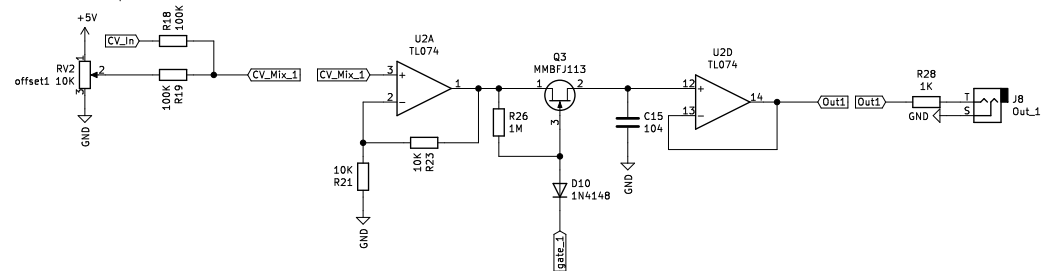
change to make potentiometer attenuate the CV input?

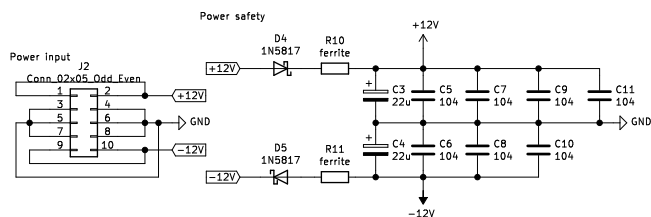
5 volt reference (could be removed?)

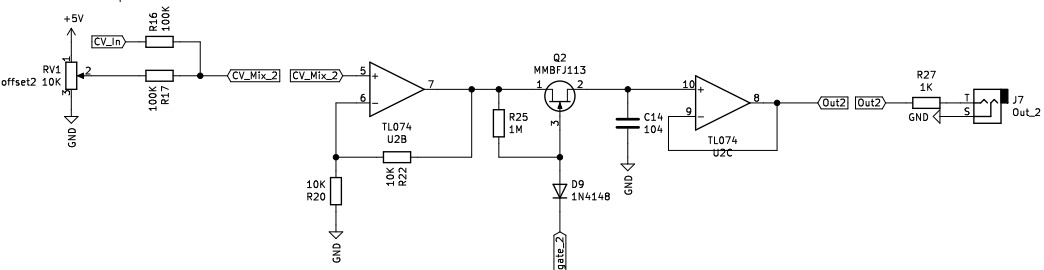
change to make potentiometer attenuate the CV input?
